Product Change Notice (PCN)

PCN Number: **PCN-0452309R**

Product(s) Affected: **UJC-VP-3-SMT-TR**

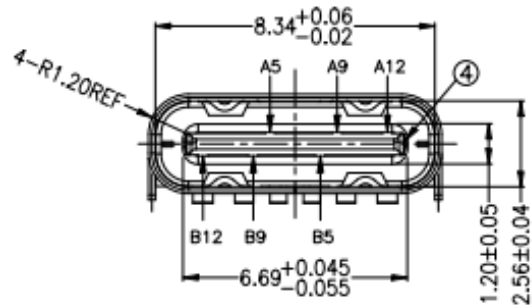
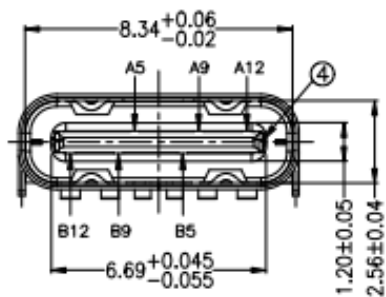
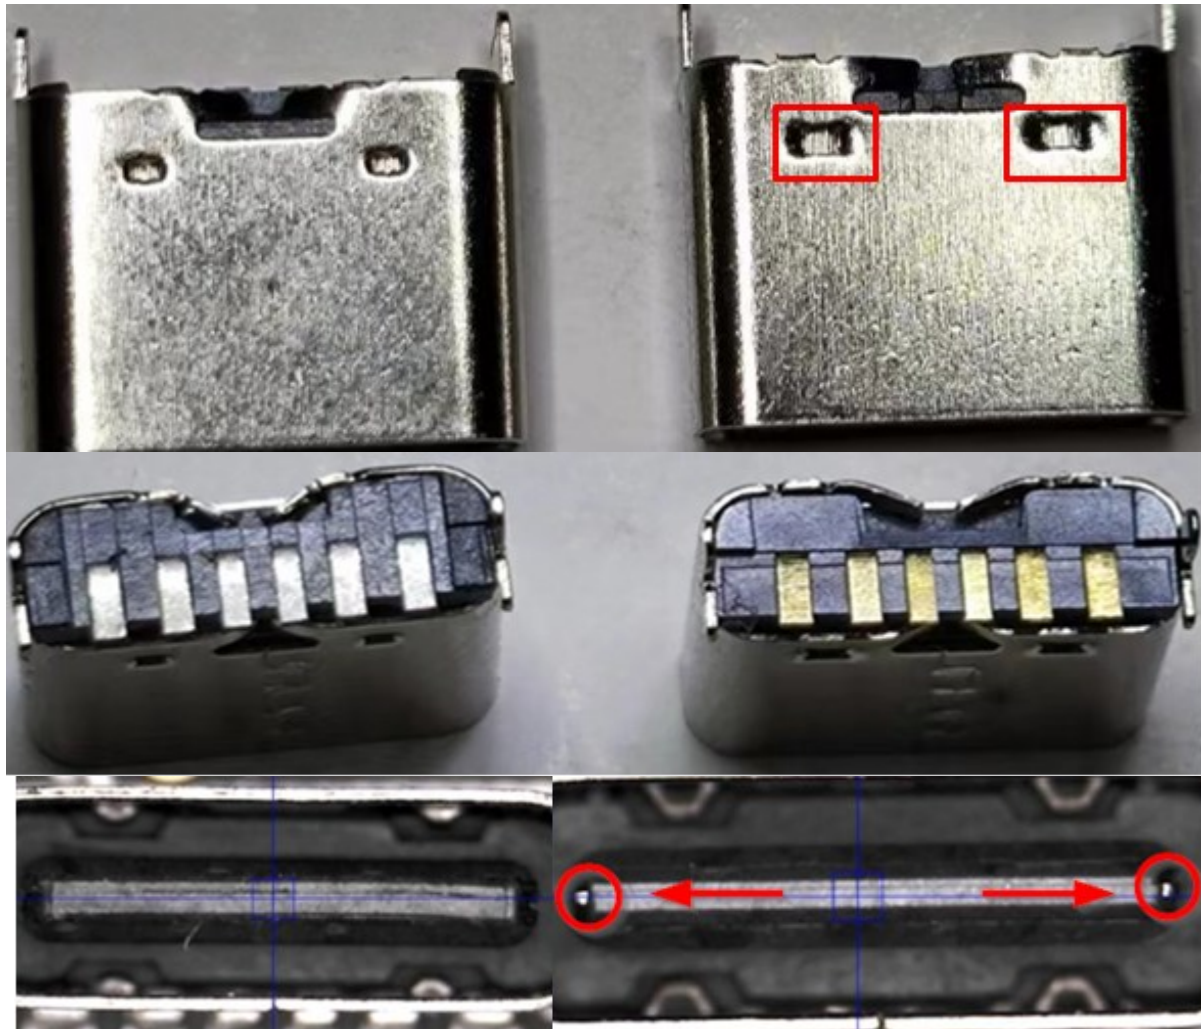
- Description of Change: *The corners of the matting face of the shell are less radial. New dimensional measure is provided for change. No dimensions defined within the previous version of the datasheet were subject to change. Terminal feet material upgraded to matte gold plating. Retention springs added for improved mating. Cosmetic changes to the shell.*
